Access Compliance Report

Public Rights-of-Way

Intersection ID: 12066	Main Street: WEYLAND_AV	Cross Street: MARLOWE_AV	Location: SW
ADA ID: 5A5724C29B30	Ramp Type: PerpDiag	Initial Pass/Fail: Fail	Overall Compliance: No
Codes/Mitigation Info/Possible Solution		Field Measurements/Component Compliance

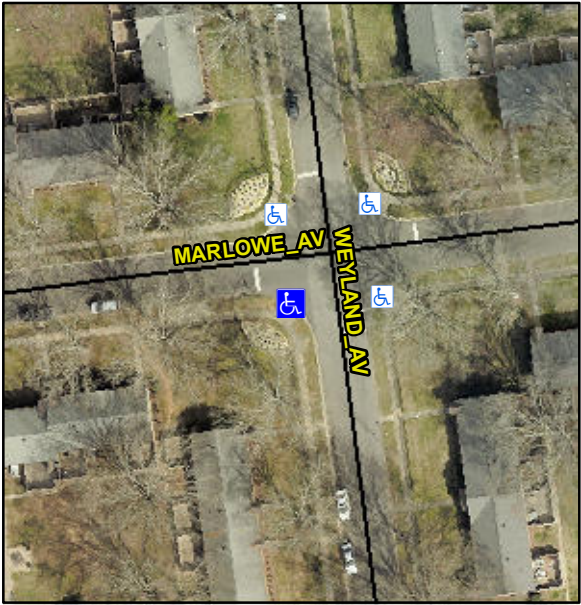
Possible Solutions:						
	Remove & Replace Curb Ramp With Two New Directional Ramps or Equivalent.						
	Surveyor Notes:						
	N/A						
	PROW/ADA:						
	Not Found, R304.2.2, R304.5.3						
Street 1 Name	WAYLAND AV	Compliance	Description	Data	Compliance	Description	Data
Stop Condition-Street 2	StopSign	N/A	Ramp Length (in)	82.0	No	Ramp Slope (%)	9.5
Street 2 Name	MARLOWE AV	Yes	Ramp Width (in)	50.0	No	Ramp XSlope (%)	2.7
Stop Condition-Street 1	StopSign	N/A	Flare Type LT	N/A	N/A	Flare Type RT	N/A
		N/A	Flare Slope LT (%)	N/A	N/A	Flare Slope RT (%)	N/A
		N/A	Flare Traversable LT?	N/A	N/A	Flare Traversable RT?	N/A
		N/A	Landing Length (in)	N/A	N/A	DWS Provided?	N/A
		N/A	Landing Width (in)	N/A	N/A	DWS Contrast?	N/A
		N/A	Landing Slope (%)	N/A	N/A	DWS Length (in)	N/A
		N/A	Landing X Slope (%)	N/A	N/A	DWS Full Width?	N/A
		N/A	Landing Curb? (Y/N)	N/A	N/A	DWS Offset (in)	N/A
		N/A	Shared Landing?	N/A			
		N/A	Gutter Ponding?	N/A	N/A	Gutter Slope (%)	N/A

N/A	Gutter Lip Ht (in)	N/A	N/A	Gutter X Slope (%)	N/A
		N/A	Painted X Walk1?	No	N/A	Painted X Walk2?	No
			X Walk 1 Direction	To E		X Walk 2 Direction	To N
		N/A	X Walk 1 Width (in)	N/A	N/A	X Walk 2 Width (in)	N/A
			X Walk 1 Slope (%)	3.0		X Walk 2 Slope (%)	2.1
			X Walk 1 X Slope (%)	1.9		X Walk 2 X Slope (%)	0.6
		N/A	Ramp inside XWalk1?	N/A	N/A	Ramp inside XWalk2?	N/A
			Road Slope (%)	2.6	N/A	Clear Space?	N/A
			Road X Slope (%)	1.6	N/A	Clear Space to XWalk (in)	N/A
		N/A	Any Obstructions?	N/A	N/A	Storm Grate/Utility Hazard?	N/A
			Obstruction Type			Storm Grate/Utility Type	
					N/A		N/A
					Yes	Surface Condition? (G/P)	Good
Total Cost:		\$ 3200.00
